DART AEROSPACE LTD	Work Order:	101944
Description: Crosstube Assembly (412 High Aft)	Part Number:	D412-664-243
Inspection Dwg: D412-664-243 Rev: E		Page 1 of 2

DRAWING NO. D412-664-243	TITLE CROSSTUBE ASS'Y (412 HI AFT)	REV. E	DART AEROSPACE LTD ENGINEERING ORDER		D.E.O. NO. D412-664-243-E-2	SHEET NO. SHEET 1 OF 1	SCALE NTS
DRAWN <i>MP</i>	CHECKED <i>ASS</i>	MFG. APPR. <i>RE</i>	APPROVED <i>MP</i>		DE APPR. <i>MP</i>		
DATE 11.09.07	DATE 11.09.19	DATE 11.09.19	DATE 11.09.19		DATE 11.09.19

DRAWING NO. D412-664-243	TITLE CROSSTUBE ASSEMBLY (412 HI AFT)	REV. E	DART AEROSPACE LTD ENGINEERING ORDER	D.E.O. NO. D412-664-243-E-4	SHEET NO. SHEET 1 OF 3	SCALE NTS
DRAWN <i>q</i>	CHECKED <i>A</i>	MFG. APPR. <i>A</i>	APPROVED <i>MP</i>	DE APPR. <i>MP</i>		
DATE 12.08.21	DATE 12.08.30	DATE 12.08.30	DATE 12/8/30	DATE 12.08.30

REMOVED ABRASION STRIP IN FAVOR OF A THIN LAYER OF PROSEAL 890. UPDATE INSTALLATION OF CHAFING SHIELDS AND REDUCE TORQUE TO 40-50 IN-LBS. THIS ENGINEERING ORDER SUPERCEDES DEO D412-664-243-E-1.

**D412-664-243
ASSEMBLY DETAIL**

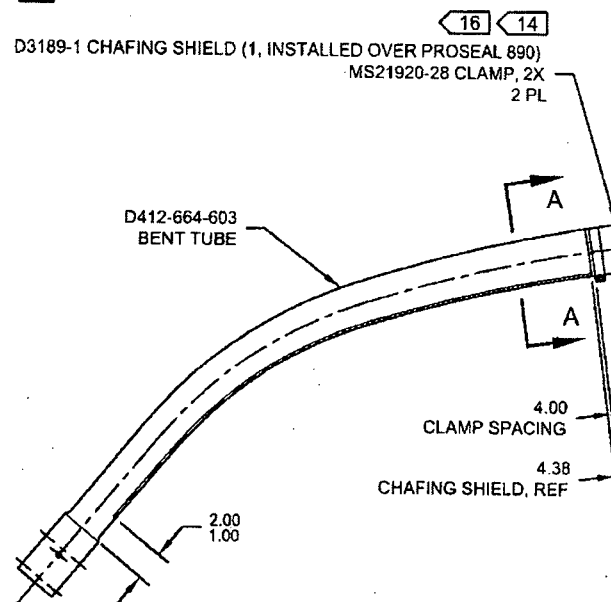
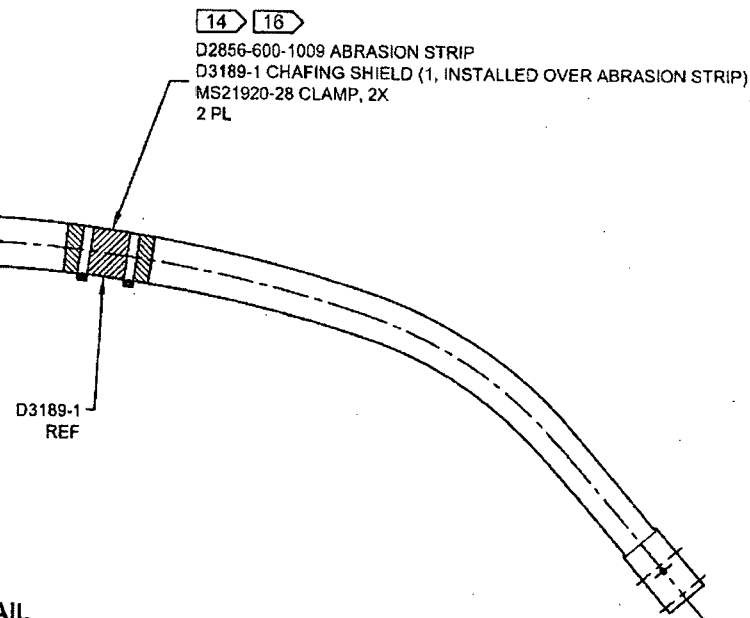
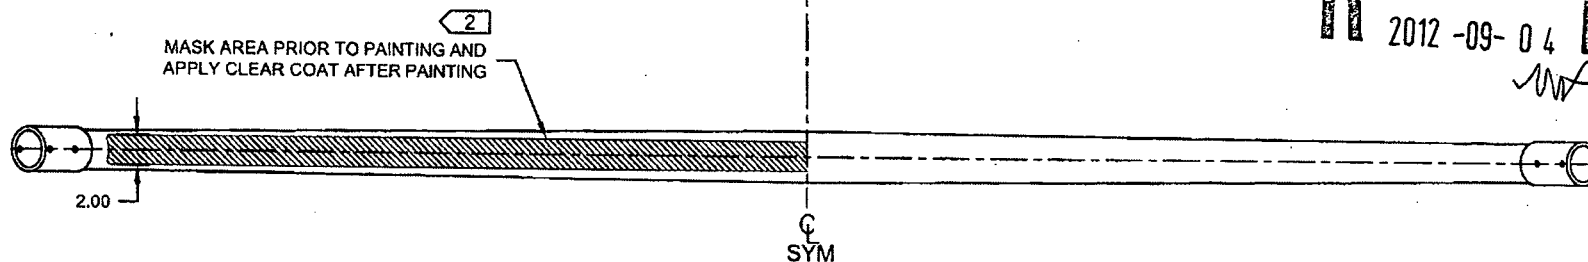
- 2) FINISH: CHEMICAL CONVERSION COAT PER DART QSI 005 4.1
PRIME INSIDE AND OUTSIDE PER DART QSI 005 4.2
MASK UNDERSIDE OF CROSSTUBE AS SHOWN (HATCHED AREA)
PAINT OUTSIDE PER DART QSI 005 4.2
AFTER PAINTING, APPLY CLEAR COAT ON HATCHED AREA
- 14) APPLY A THIN COAT OF PROSEAL 890 ON INSIDE CONCAVE SURFACE OF D3189-1 CHAFING SHIELD AND LET CURE PER MANUFACTURER'S INSTRUCTIONS. INSTALL PROSEALED D3189-1 CHAFING SHIELD ONTO CROSSTUBE BY APPLYING A THIN COAT OF PROSEAL 890 ONTO CROSSTUBE. BE SURE TO ELIMINATE ANY AIR GAPS.
- 16) TORQUE CLAMPS ON D2896-1 SUPPORT 80 TO 100 IN-LB. **TORQUE CLAMPS ON D3189-1 CHAFING SHIELD 40 TO 50 IN-LB.**
ENSURE AT LEAST 1.5 THREADS SHOWING IN SAFETY AND THAT NUT HAS NOT BOTTOMED-OUT AFTER TORQUING.

- 2) FINISH: CHEMICAL CONVERSION COAT PER DART QSI 005 4.1
PRIME INSIDE AND OUTSIDE PER DART QSI 005 4.2
PAINT OUTSIDE PER DART QSI 005 4.2
- 14) INSTALL D2856-600-1009 ABRASION STRIPS WITH A 0.13 REF GAP ON BOTTOM SIDE OF CROSSTUBE PER QSI 035.
- 16) TORQUE CLAMPS 80 TO 100 IN-LB. ENSURE AT LEAST 1.5 THREADS SHOWING IN SAFETY AND THAT NUT HAS NOT BOTTOMED-OUT AFTER TORQUING.
